Planning Commission Vote Report

Location: 13426 Olive Boulevard

Petition: **P.Z. 09-2020 Total Access Urgent Care (13426 Olive Blvd):** A request for a change in zoning from a “C-8” Planned Commercial District to a “PC” Planned Commercial District for a 3.23 acre tract of land located south of Olive Boulevard, east of North Woods Mill Road (16Q330911).

Subject: PZ 09-2020 TAUC Public Hearing Issues Letter

Figure 4: Preliminary Development Plan

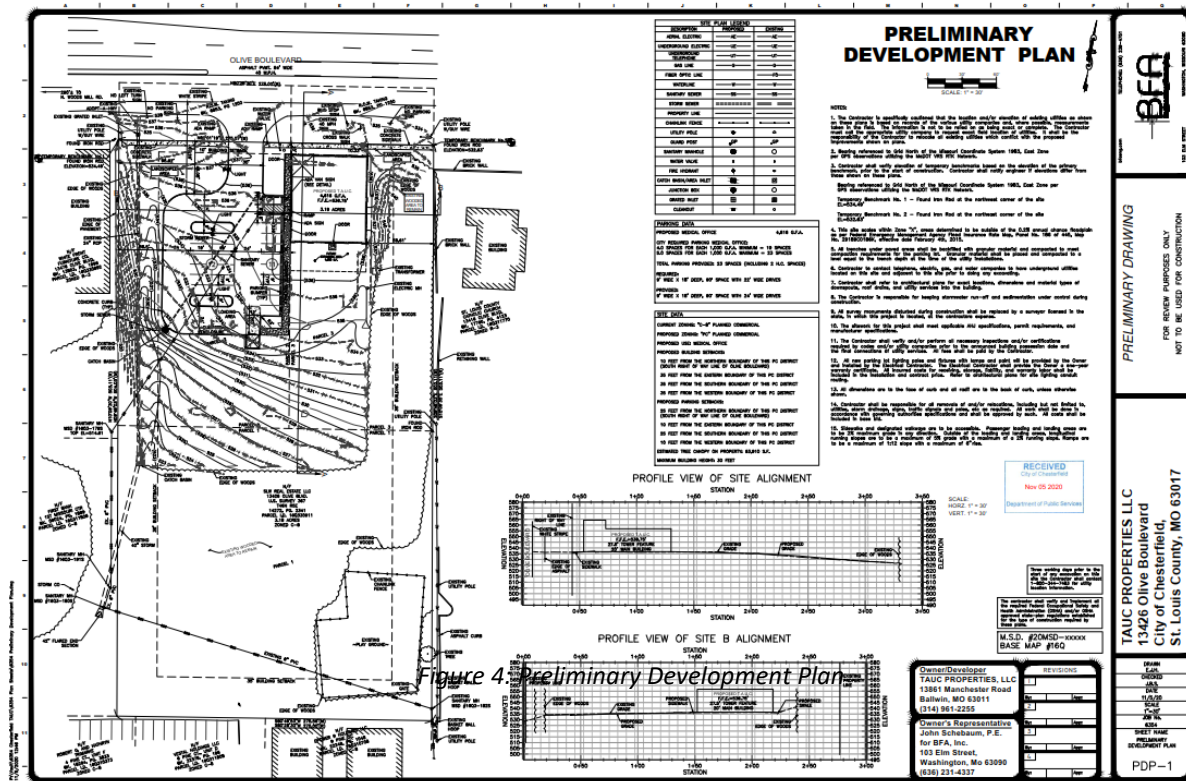
1. **Setbacks:** There was considerable discussion by both Planning Commission and the attendees regarding the requested 10' setback from Olive Boulevard. Specific concerns included the appropriateness of the setback given the 30' landscape buffer requirement along arterial roadways. Provide a response that necessitates the 10' setback.

2. **Landscape Buffer:** Similar to Issue Comment 1, there was discussion regarding the required 30' landscape buffer in contrast to the proposed 10' landscape buffer. Provide a response that necessitates the 10' landscape buffer.

1. The plan depicts an existing playground located on the southeast corner of the property, which is proposed to remain. The playground was also discussed at the December 14th, 2020 Public Hearing. Please provide clarification as to how the playground will be incorporated into the proposed use for the property.

2. Revise the plan to remove the labels for the number of parking spaces, and replace with labels indicating "general parking areas." The number of parking spaces is addressed at the Site Development Plan stage.

The applicant revised the proposed setback from Olive Boulevard from their initial request of 10' to 20'. The applicant noted that the request is driven by the need for visibility from Olive Boulevard, particularly with the close position of the building on the adjacent property to the west to Olive Boulevard. Per the applicant's response, prominent visibility from a main roadway is crucial for patients in need of services to locate the facility. The applicant further added that the building will be designed in a way that is integral to the community of the City of Chesterfield.

The applicant responded that the existing Steak 'n Shake building has a landscape buffer that is less than 20'. The applicant has proposed a 20' landscape buffer between the building and Olive Boulevard, with substantial amounts of landscaping in other areas of the site.

- A reduction in the landscape buffer requirement along Olive Boulevard from the required thirty feet (30') to twenty feet (20'). The applicant had previously proposed a buffer of ten feet at the Public Hearing.
- Utilization of the existing access into the site, so no new access points are required.

- **The existing playground will not have any impact on the proposed use of the property. The existing playground is separated from the proposed development by an existing wooded area to remain. At this time, TAUC is working on ways to donate the playground area to the adjacent church.**

- **The plan has been updated.**
3. Be advised, any future expansion would require an ordinance amendment, as the current request is for a 4,616 sf GFA area building, and all site-specific criteria is for the current proposed structure only. Any future expansion would also require additional parking.

DRAWN
E.J.H.
CHECKED
J.B.S.
DATE
12/18/20
SCALE
1" = 30'
JOB No.
6354
SHEET NAME
PRELIMINARY
DEVELOPMENT PLAN
PDP-1

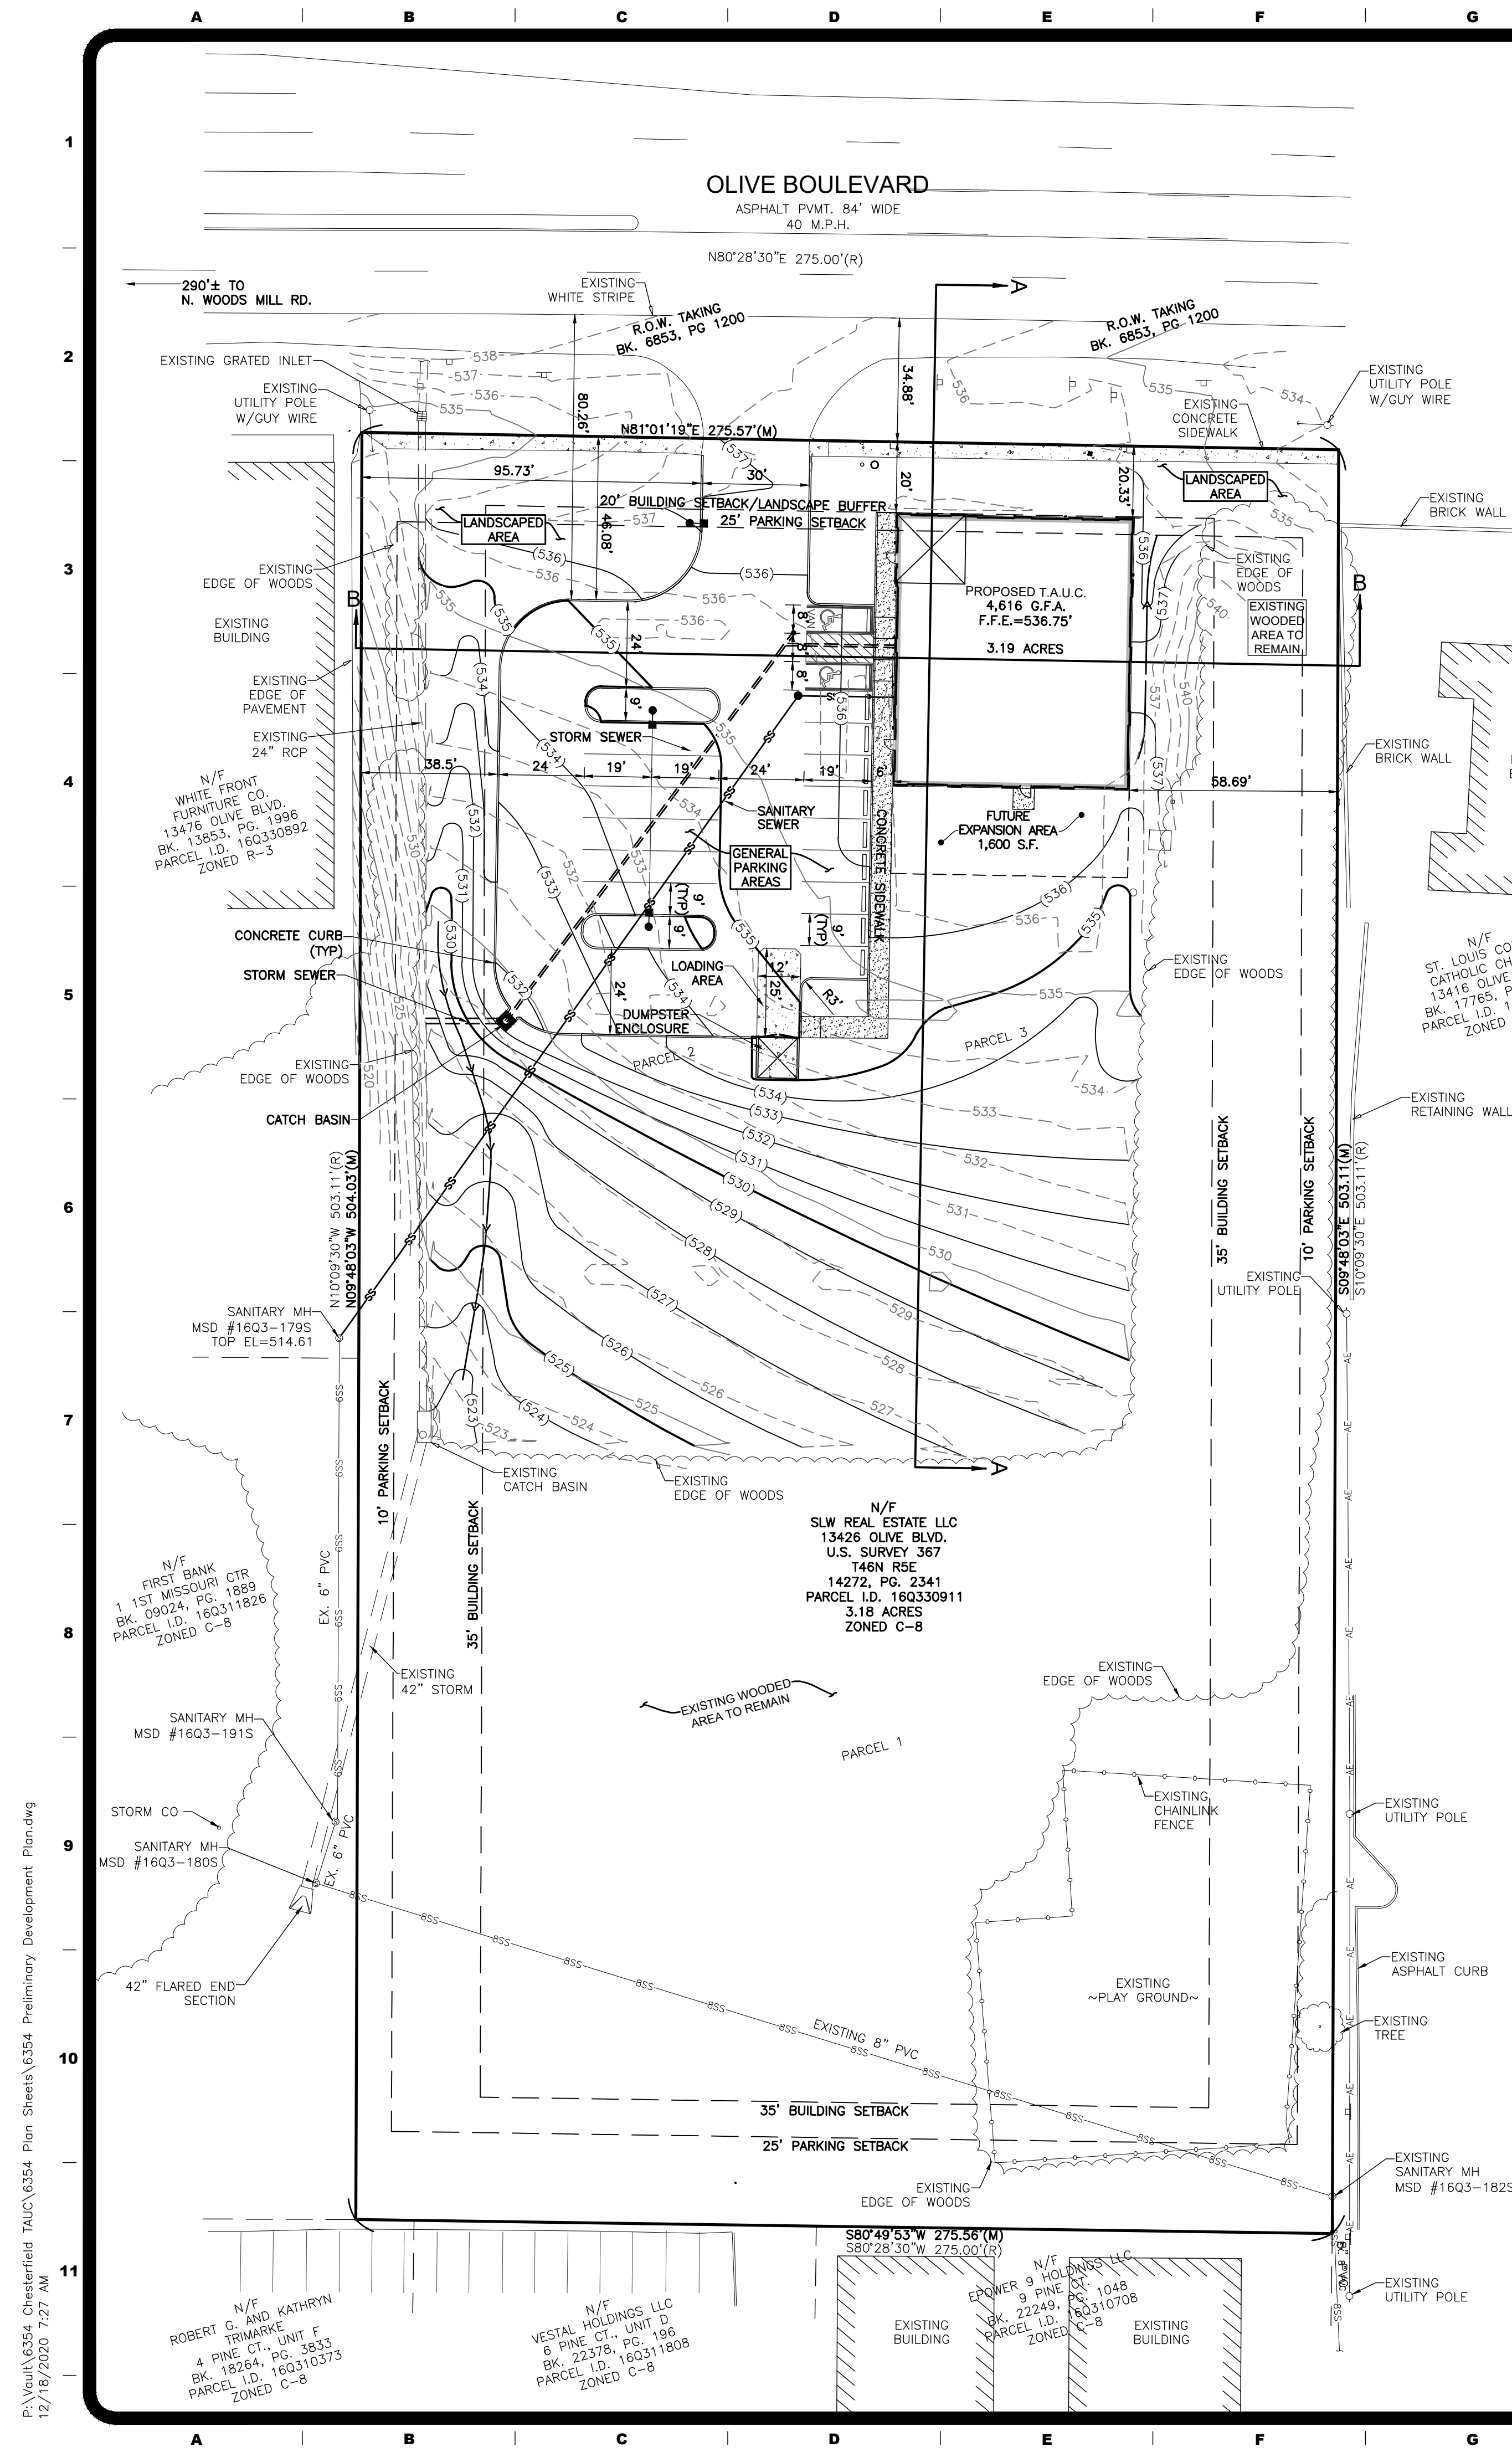
1. Setbacks: There was considerable discussion by both Planning Commission and the attendees regarding the requested 10' setback from Olive Boulevard. Specific concerns included the appropriateness of the setback given the 30' landscape buffer requirement along arterial roadways. Provide a response that necessitates the 10' setback.
 - **We appreciate the feedback provided by the Planning Commission and attendees during our public hearing, as well as the input from City Staff throughout the project. After much discussion amongst the Total Access Urgent Care Development Team, we have revised our proposed Building Setback along Olive Boulevard to 20'.**

2. Landscape Buffer: Similar to Issue Comment 1, there was discussion regarding the required 30' landscape buffer in contrast to the proposed 10' landscape buffer. Provide a response that necessitates the 10' landscape buffer.
 - **Based on the response to the previous comment, our proposed landscape buffer will also be revised to 20' along Olive Boulevard. The proposed landscape buffer along Olive Boulevard is directly correlated with the building setback.**

As previously discussed, the nature of our reduced setback request is based on the need for our development to have proper visibility to motorists along Olive Boulevard. Our site has limited visibility due to the existing development to the west with a building setback of less than 10', and to the east by an existing wooded area that we propose to maintain in order to keep a natural separation between our property and Incarnate Word. Total Access Urgent Care strives on the quality of the medical service provided and the efficiency of customer service. By providing prominent visibility along a main roadway, those in need of critical services are able to conveniently and effortlessly locate our facility and obtain the assistance needed. The TAUC building has been designed to provide an appealing and tasteful look that will integrate into the City of Chesterfield community, and provide a welcoming presence to the Olive Boulevard corridor.

The existing Steak N' Shake development has less than a 20' landscape buffer along Olive Boulevard. The proposed TAUC Development will have a 20' landscape buffer between the building and Olive
